UNITED STATES PATENT AND TRADEMARK OFFICE

10/578,339

Rainer Strohmaier

Office Action Summary	Application No. 10/578,339	Applicant(s) STROHMAIER ET AL.	
	Examiner GURPREET KAUR	Art Unit 1795

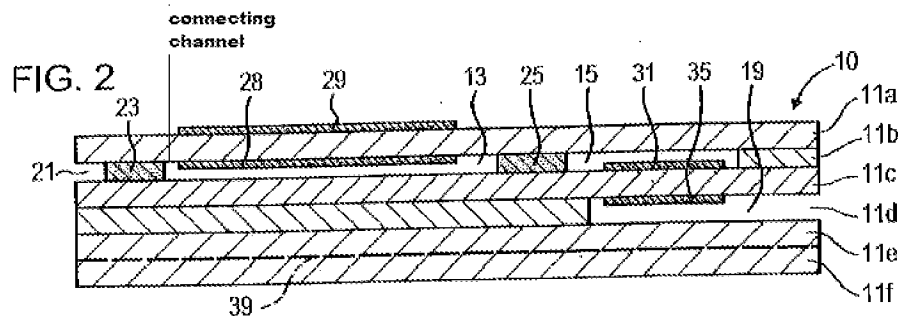
Regarding claim 34, Stahl teaches a Nernst cell (measurement space, 15) made up of electrolyte (11b) and two electrodes (31 and 35), 31 is inside the measurement space, 15 and 35 is exposed to pump air in a reference channel, 19 (see figure 2);

a pump cell (measurement gas space 13) with the pump electrodes (electrodes 28 and 29) for pumping the oxygen. Electrode, 28 is inside the compartment, 13 and electrode, 29 is outside and exposed to gas mixture (see figure 2). Stahl teaches that inner electrodes (28 and 31) can be combined to form a continuous electrode (see col. 4, ll. 14-16), therefore it would obvious to one of ordinary skill in the art to assert from the teaching of Stahl combined inner electrodes as one electrode is present in the measuring chamber

a connecting channel (see annotated figure 2 below) to exhaust port, 21 which opens to measuring chamber (15), the diffusion path (gas intake port, 21 which is equivalent to channel) is part of the storage volume (measuring gas compartment, 13) and diffusion barrier (25) is situated between the measuring chamber (15) and storage volume (see figure 2).
